Design Compliance Report

REF Submission Design Review

**Greenway Park Public School Upgrade and New Public Pre School at
Wyattville Drive, West Hoxton, NSW**

Report Number & Revision:	MSA2623_DDA_GRE_1
Prepared For:	NSW Department of Education
Date of Issue:	19 February 2025

Table 1.0 – Significant DDA Mitigation Measures

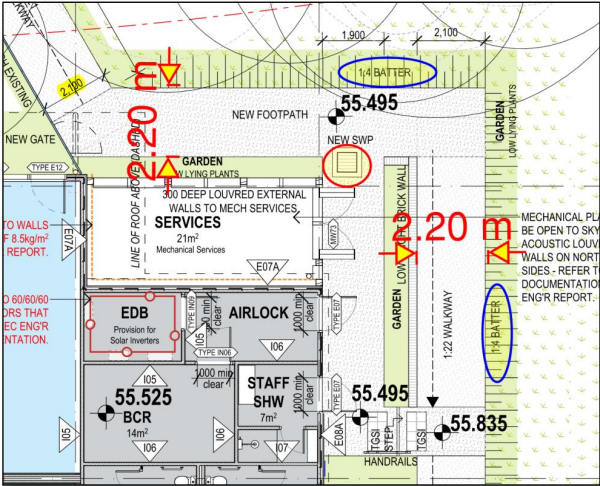
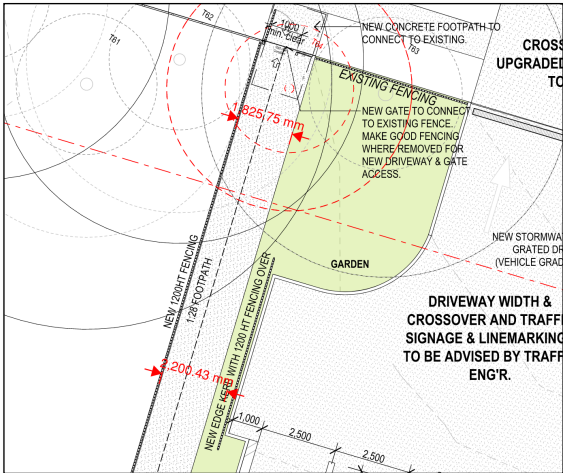
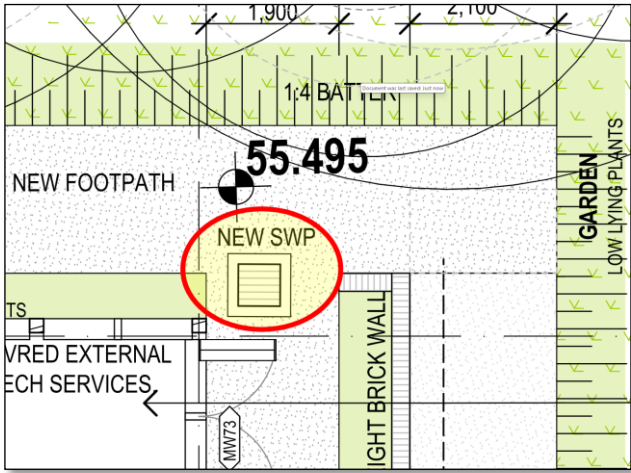
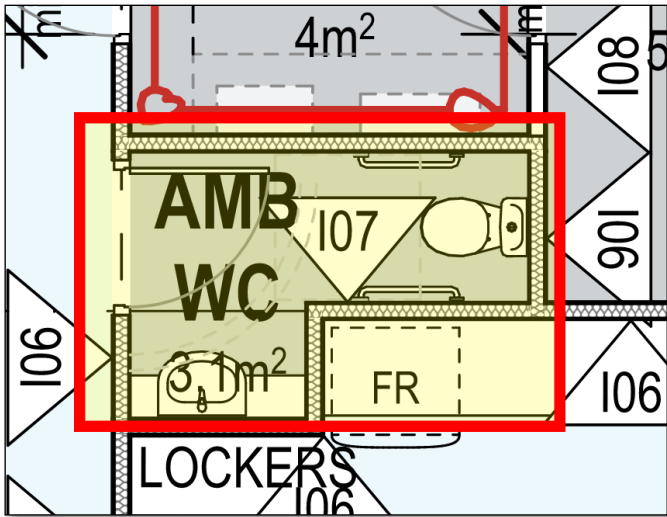
#	Clause	DDA Mitigation Measures	Status
1.	Clause 13 of AS1428.1	<p>Circulation Space at Doorways</p> <p>The following extracts do not appear to provide either adequate circulation spaces at doorways or gates or a maximum crossfall of 1:40:</p> 	DOES NOT COMPLY
